Access Compliance Report

Public Rights-of-Way

(Curb Ramps)

Intersection ID: 14366	Main Street: E_KINGSTON_AV	Cross Street: WINTHROP_AV	Location: W
ADA ID: 96548446FE71	Ramp Type: Directional1	Initial Pass/Fail: Fail	Overall Compliance: No
Severity Score: 22.5			
Codes/Mitigation Info/Possible Solution		Field Measurements/Component Compliance

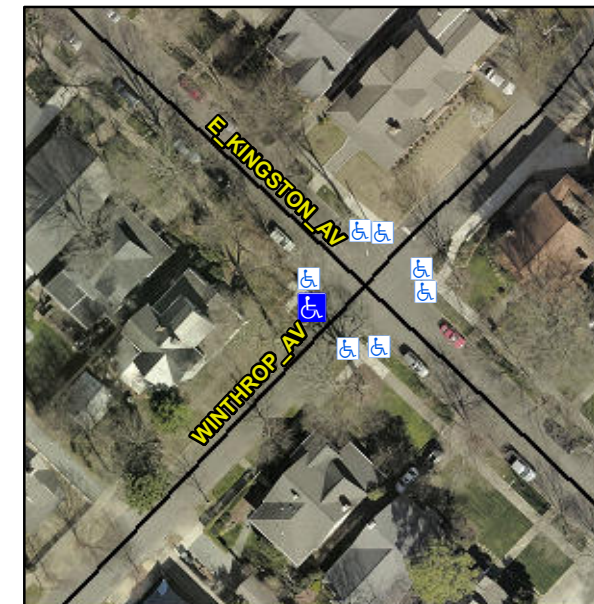
R304.5.1, R304.2.2, R304.5.3

Compliance	Description	Data	Compliance	Description	Data
N/A	Ramp Length (in)	101.0	N/A	Grade Break?	N/A
No	Ramp Width (in)	36.0	N/A	Grade Break Slope (%)	0.0
No	Ramp Slope (%)	9.3	N/A	Grade Break XSlope (%)	0.0
No	Ramp XSlope (%)	3.0			
N/A	Flare Type LT	N/A	N/A	Flare Type RT	N/A
N/A	Flare Slope LT (%)	N/A	N/A	Flare Slope RT (%)	0.0
N/A	Flare Traversable LT?	N/A	N/A	Flare Traversable RT?	N/A
N/A	Landing Length (in)	0.0	N/A	DWS Provided?	N/A
N/A	Landing Width (in)	0.0	N/A	DWS Contrast?	N/A
N/A	Landing Slope (%)	0.0	N/A	DWS Length (in)	N/A
N/A	Landing X Slope (%)	0.0	N/A	DWS Full Width?	N/A
N/A	Landing Curb? (Y/N)	N/A	N/A	DWS Offset LT (in)	N/A
N/A	Shared Landing?	N/A	N/A	DWS Offset RT (in)	N/A
N/A	Gutter Ponding?	Yes	N/A	Gutter Slope (%)	N/A
N/A	Gutter Lip Ht (in)	0.0	N/A	Gutter X Slope (%)	N/A
N/A	Painted X Walk1?	No		Road Slope (%)	4.5
	X Walk 1 Direction	To SE		Road X Slope (%)	1.5
	X Walk 1 Width (in)	N/A		Clear Space?	N/A

Remove & Replace Entire Ramp.
